West Capital Airpark Phase 1B-2 Residential (Novatech Phase 2B) Stormwater Management Report

**West Capital Airpark – Phase 1B-2 Residential
1500 Thomas Argue Road
Ottawa, Ontario**

**Reference: West Capital Airpark – Phase 1B-2 Residential
Stormwater Management Report
1500 Thomas Argue Road, Ottawa
Our File No: 102085
City File No.: D07-16-22-0017**

This report has been revised to address comments from the City of Ottawa as indicated in the cover letter. The City review comments and response to comments are included in **Appendix A** for reference.

DRAWING NAME: EROSION & SEDIMENT CONTROL PLAN

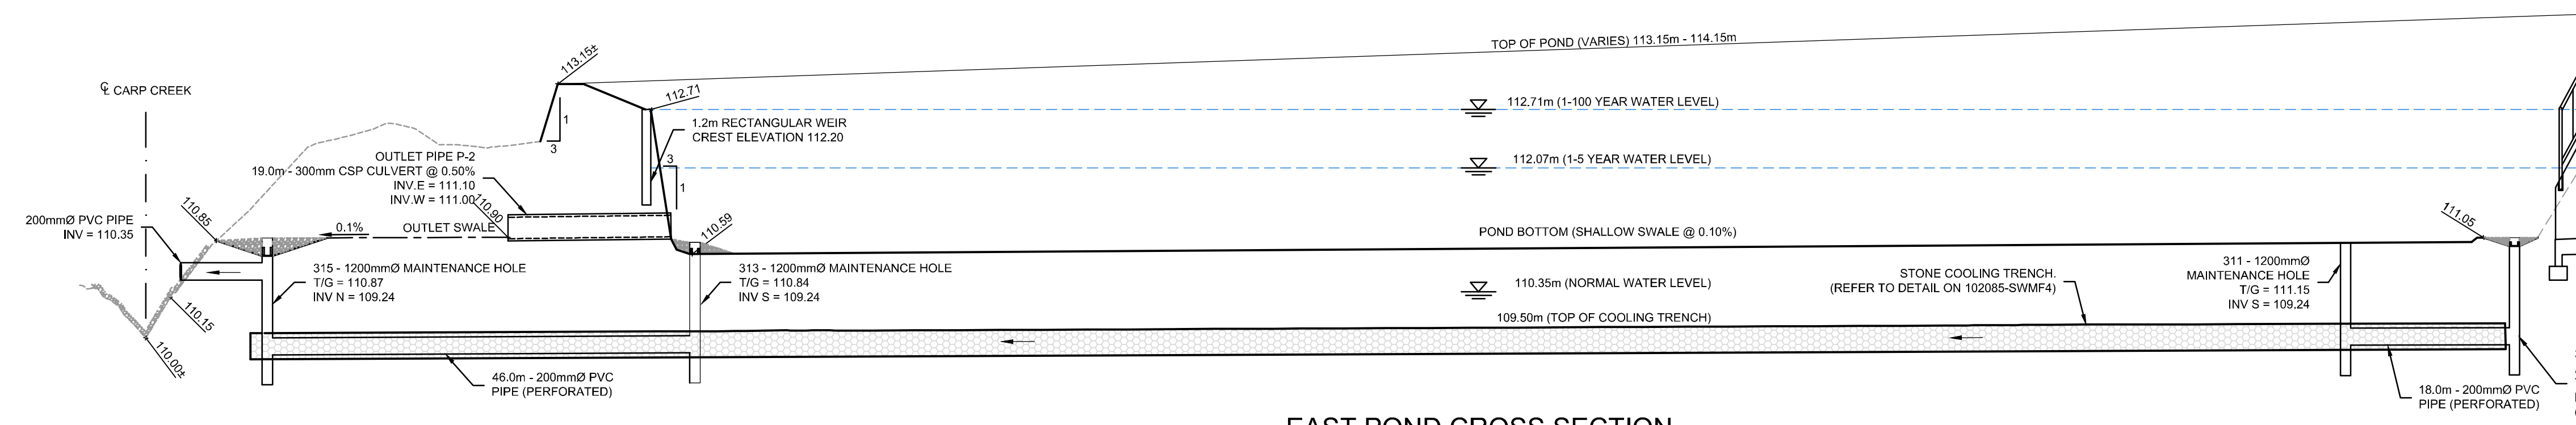
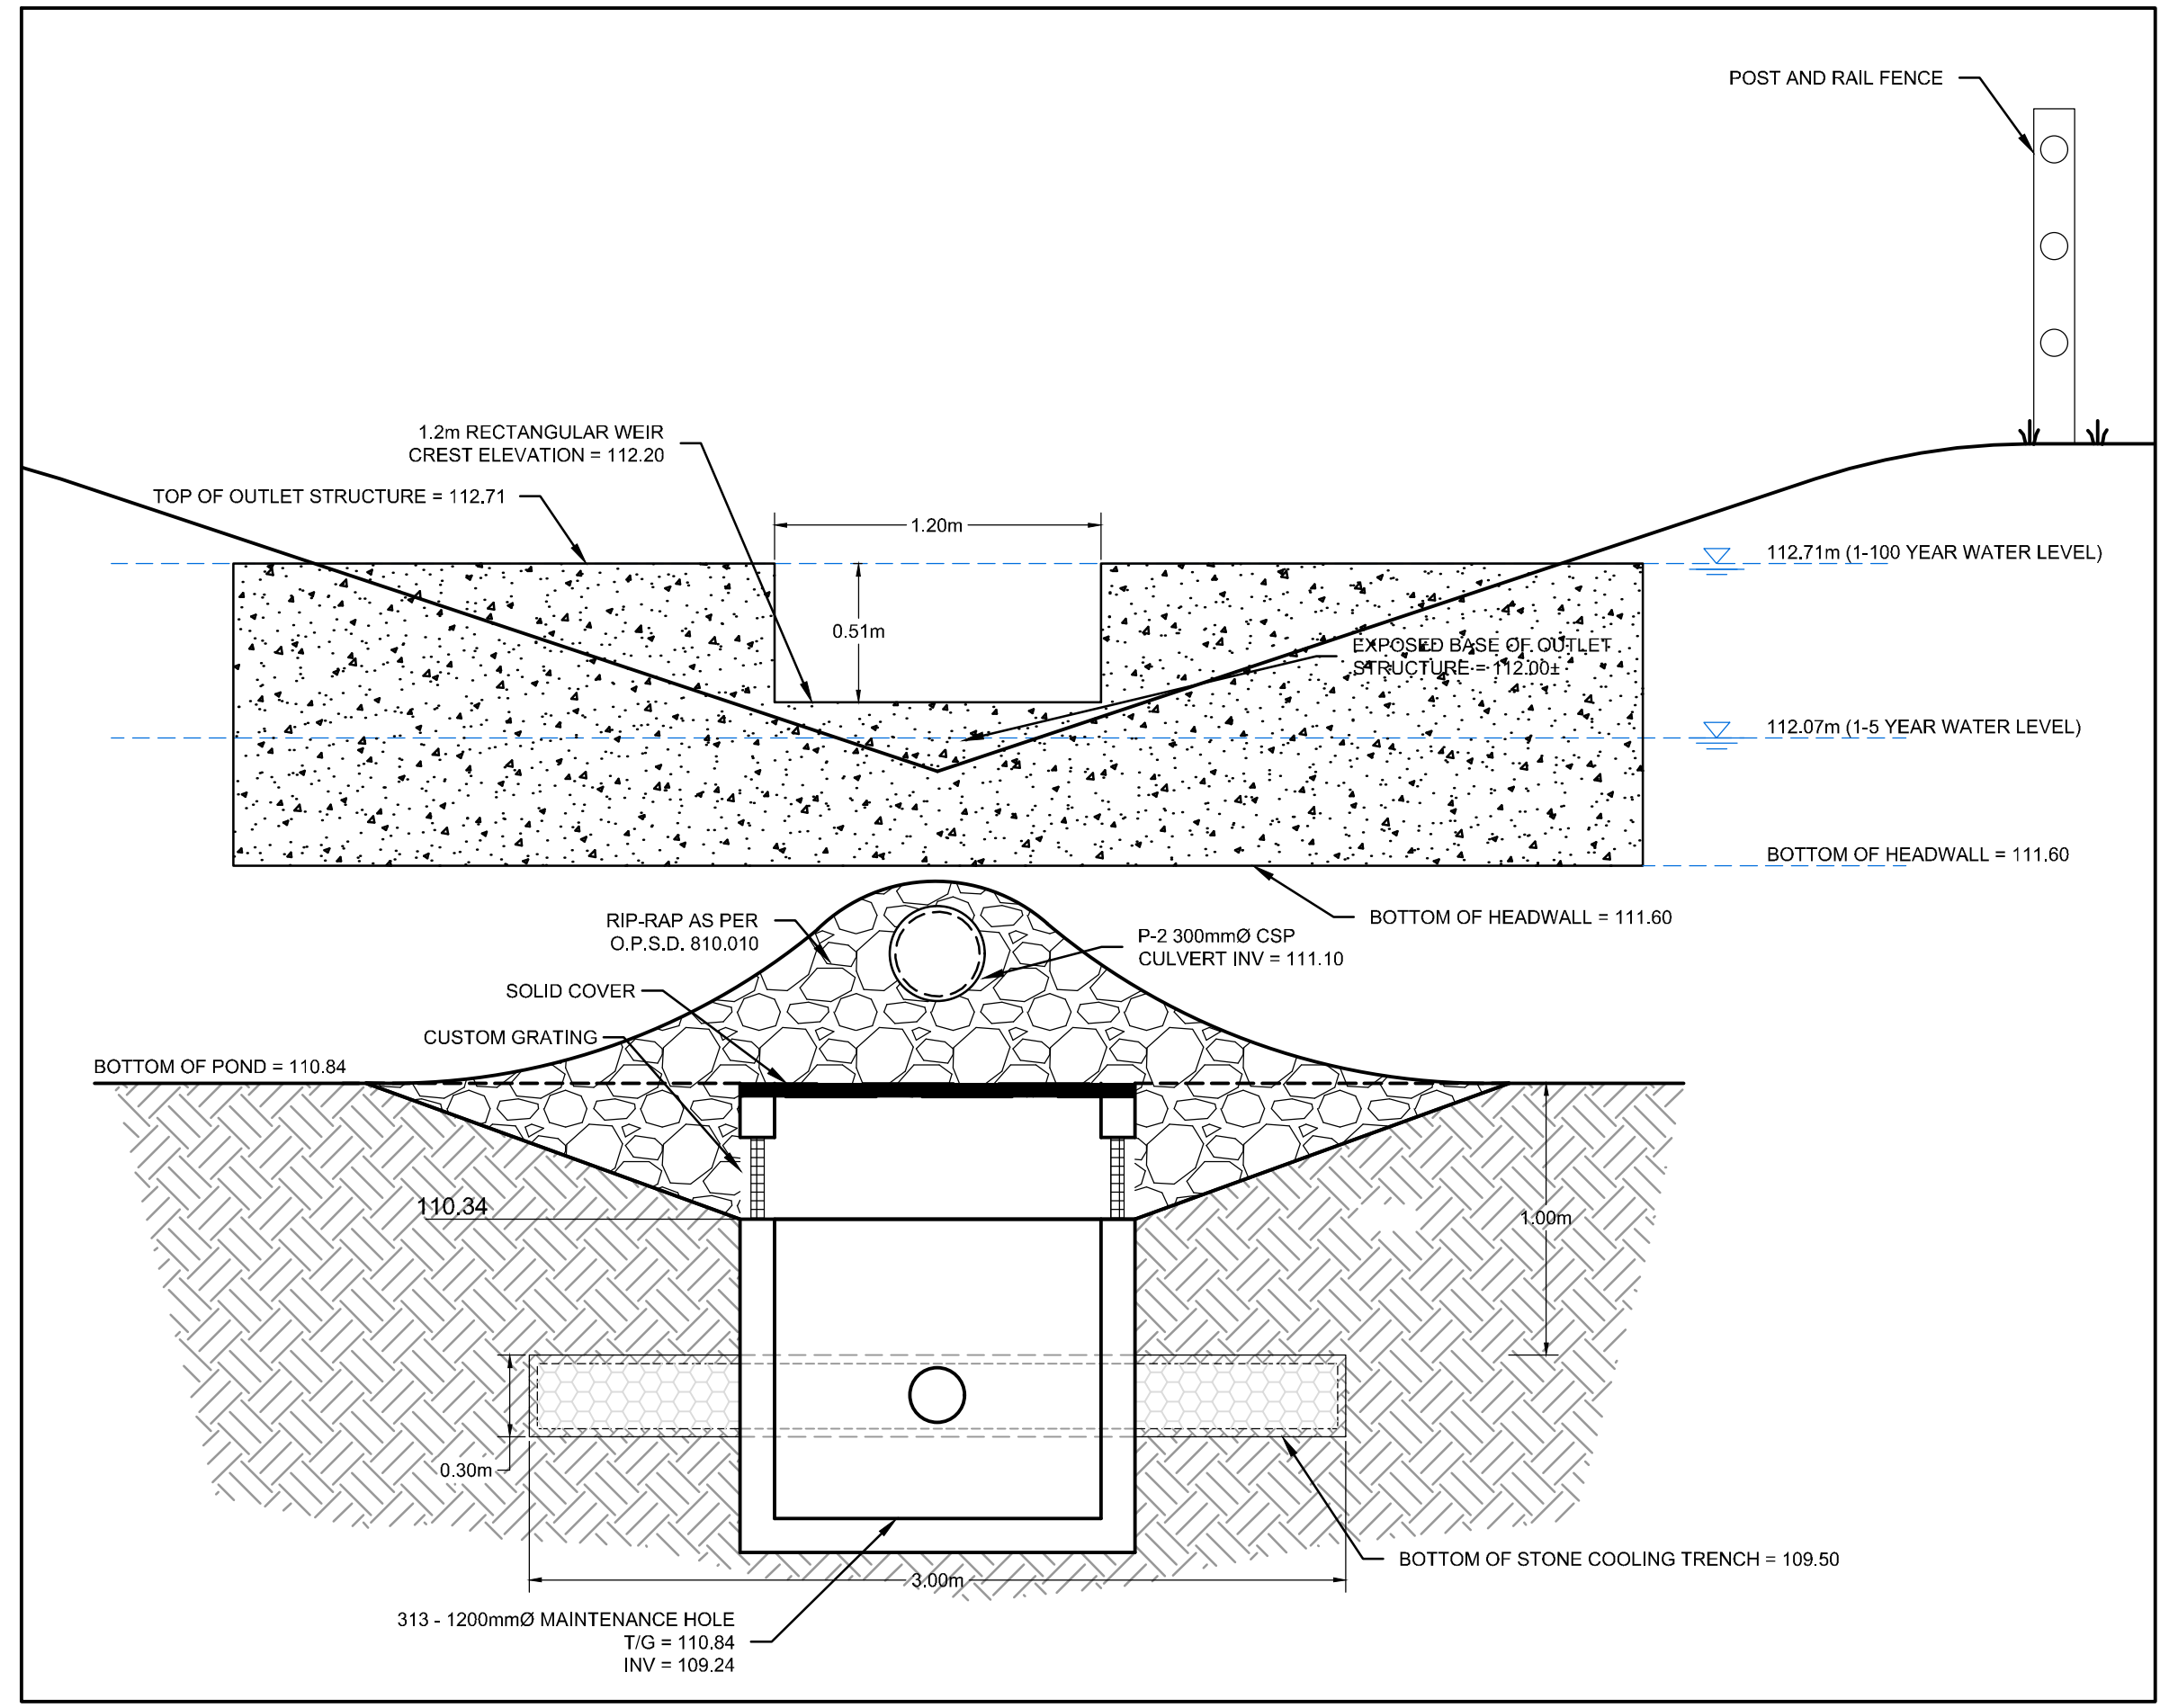
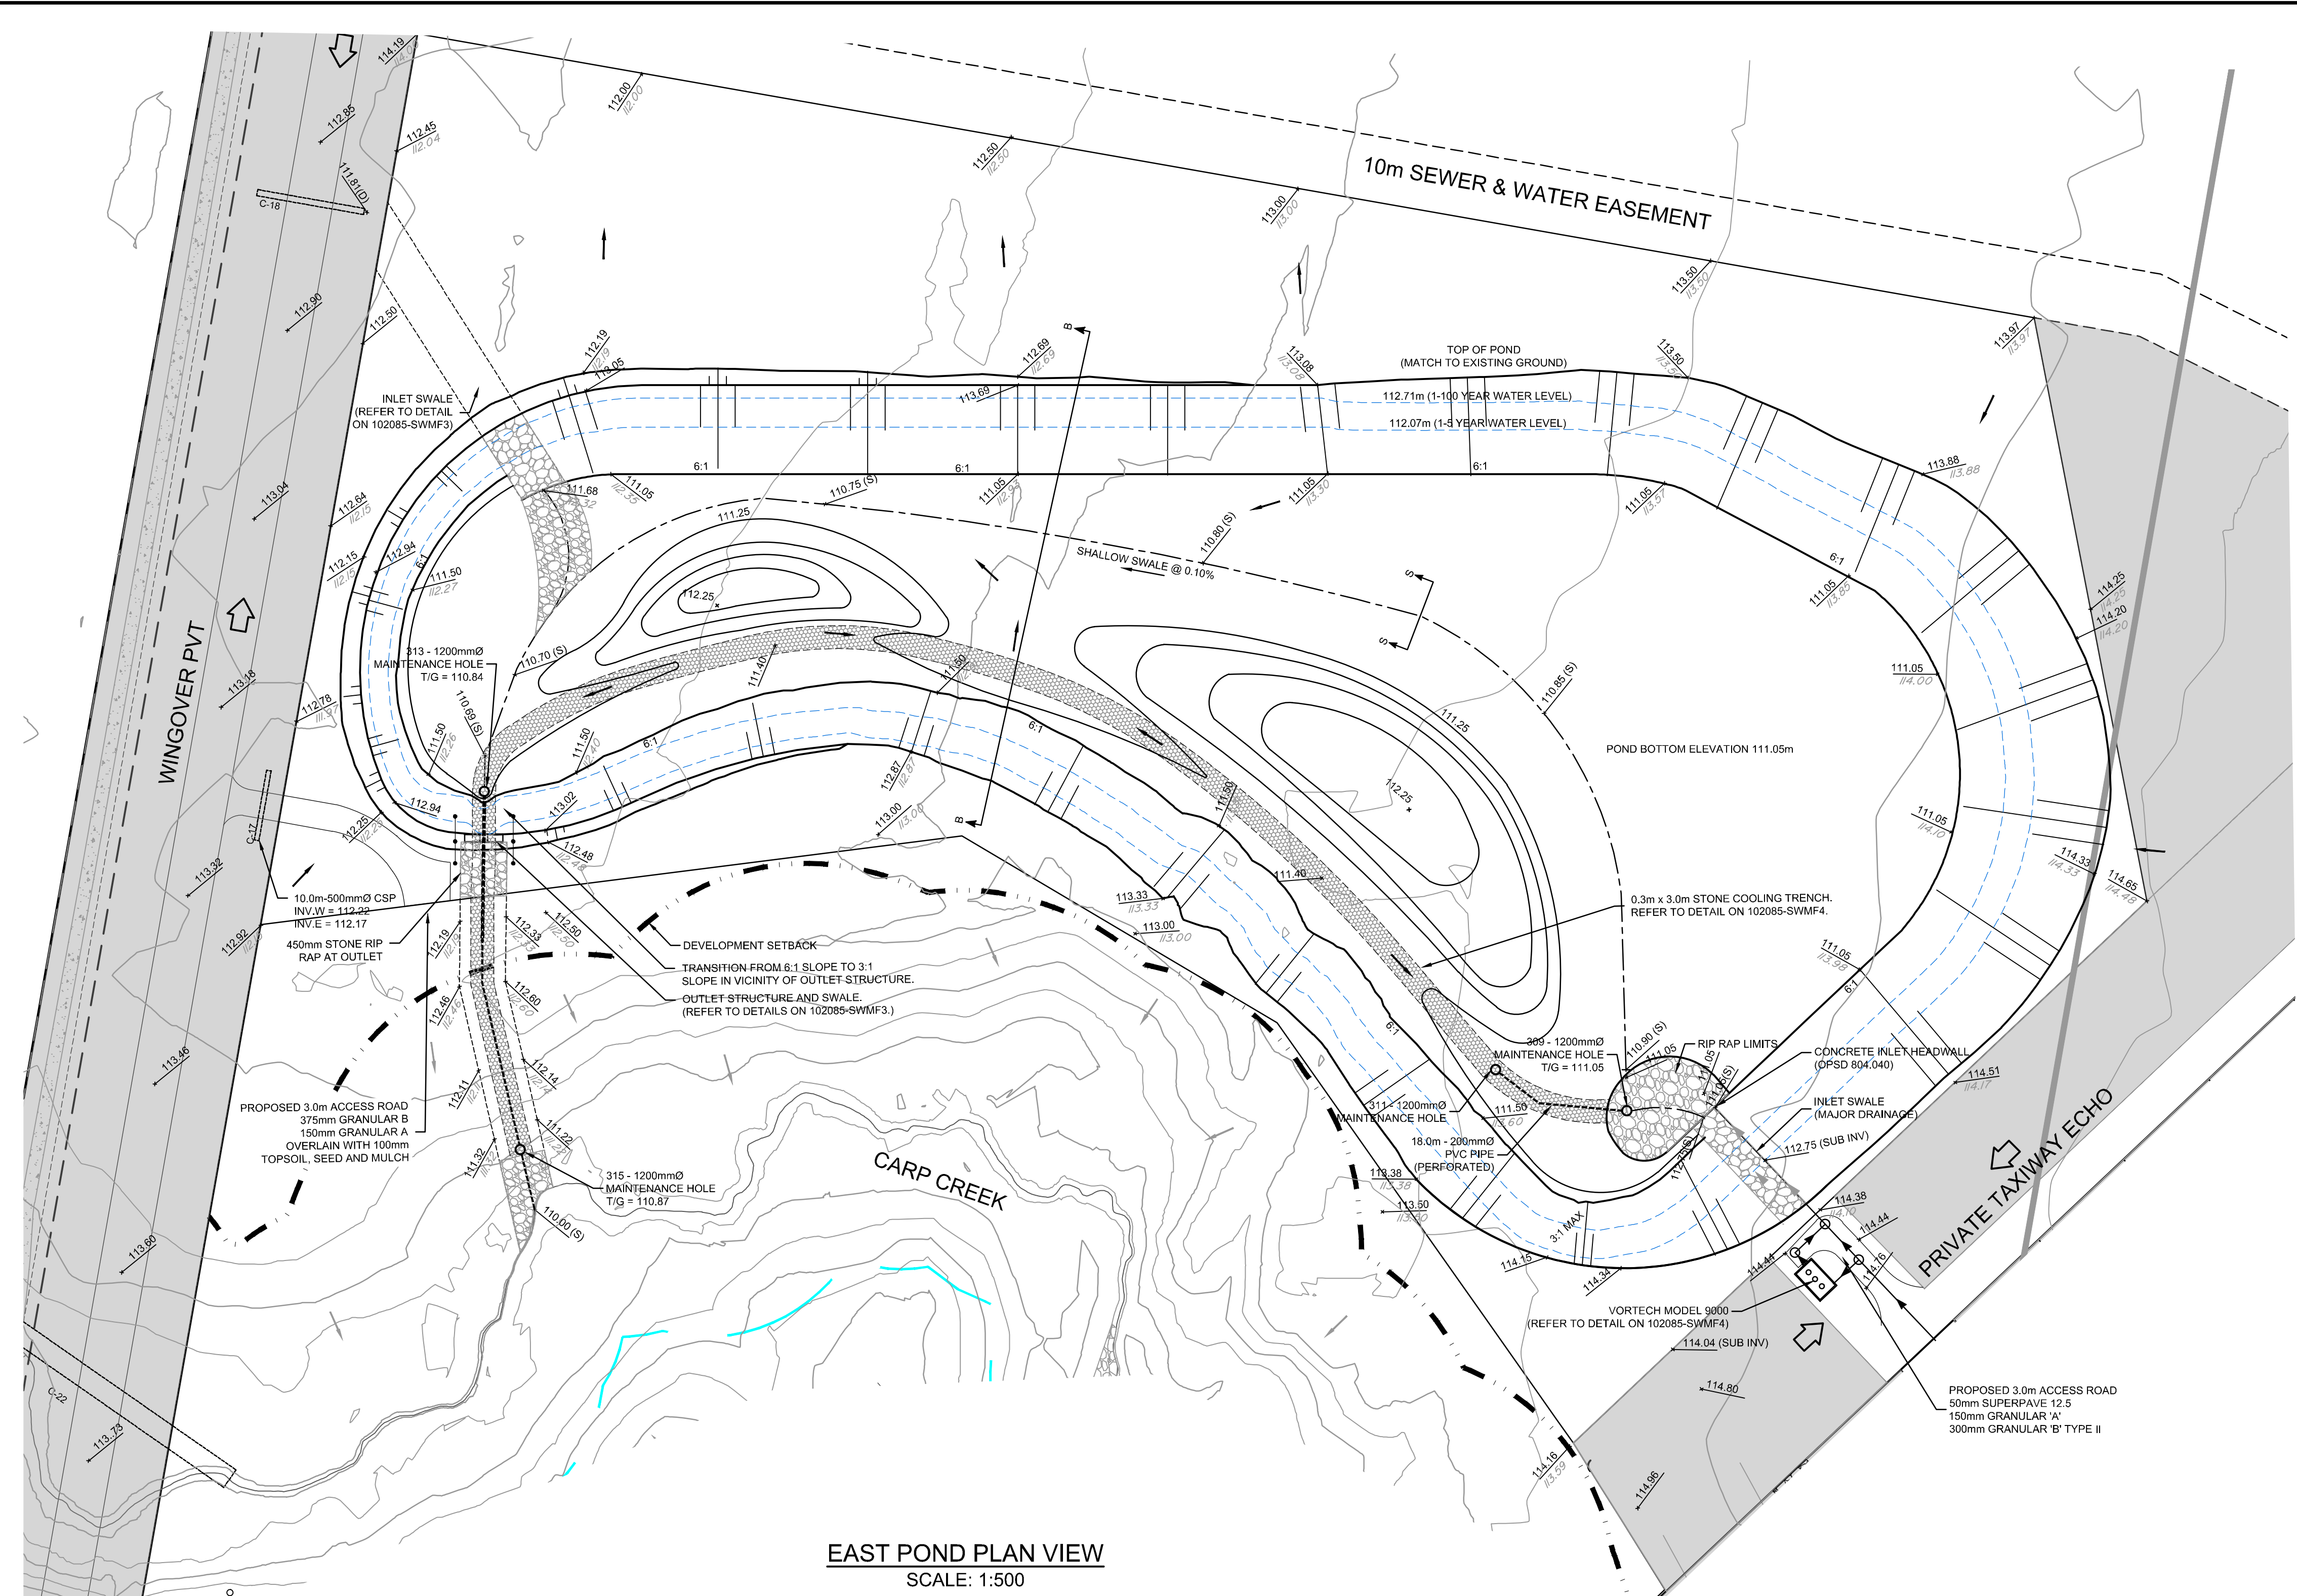
25	Please consider protecting proposed infiltration units by capping end until the site is stabilized.	LIDs			Filter bags are to be placed under all rear yard catch basin lids until the site is stabilized. Refer to drawing 102085-ESC3.	
26	As per condition 63 of the subdivision agreement. Is the infiltration, OGS, SWM pond, temperature mitigation operating as designed. Please provide the monitoring information to date as required through the ECA.	LIDs			Due to ongoing buildout of the homes in Phase 1B-1 residential, temperature monitoring has not begun. Temperature monitoring program will begin following additional buildout of Phase 1B-1.	
27	PCSWMM hydrologic modeling routine chosen should not assume zero percent imperviousness. It will underestimate runoff and peak flows. A minimum 7% (C=0,25) should be used in the model.	General			Noted, these areas have been updated to have a 7% imperviousness.

25	Please consider protecting proposed infiltration units by capping end until the site is stabilized,	Filter bags are to be placed under all rear yard catch basin lids until the site is stabilized. Refer to drawing 102085-ESC3.	No further comment.
26	As per condition 63 of the subdivision agreement. Is the infiltration, OGS, SWM pond, temperature mitigation operating as designed. Please provide the monitoring information to date as required through the ECA.	Due to ongoing buildout of the homes in Phase 1B-1 residential, temperature monitoring has not begun. Temperature monitoring program will begin following additional buildout of Phase 1B-1.	Noted
